APPLICATION NO.	FILING DATE	FIRST NAMED INVENTOR	ATTORNEY DOCKET NO.	CONFIRMATION NO.
10/771,997	02/04/2004	Osamu Nozawa	0524-0139.01	4072

Office Action Summary	Application No. 10/771,997	Applicant(s) NOZAWA ET AL.	
	Examiner Rodney G. McDonald	Art Unit 1753

DETAILED ACTION

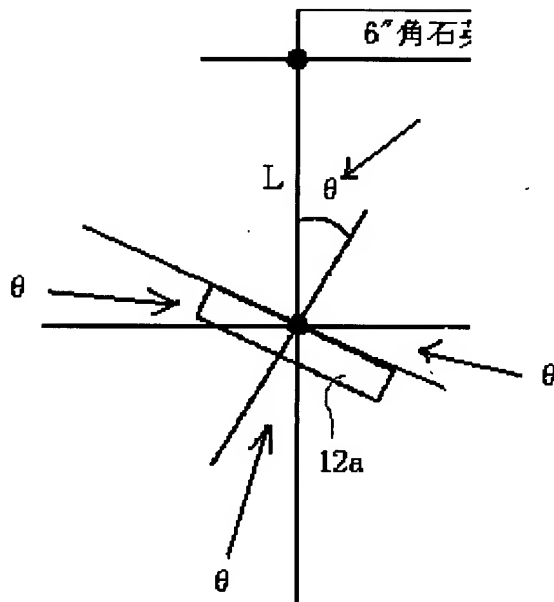
The differences not yet discussed are the predetermined angle (Claim 34), the angle being 10 to 30 degrees (Claim 35) and the angle being 10 to 15 degrees (Claim 36).

Regarding the angle (Claims 34-36), Satoshi teach providing the opposite surface of the substrate and the target at 10 to 60 degrees for forming photomask blanks. (See Machine Translation 0015; Fig. 4; Annotated Fig. 4 below)

The motivation for utilizing a particular angle is that it allows for improving the distribution of the film in the plane of the substrate. (See Abstract)

Therefore, it would have been obvious to deposit at a particular angle as taught by Satoshi because it allows for improving the distribution of the film in the plane of the substrate.
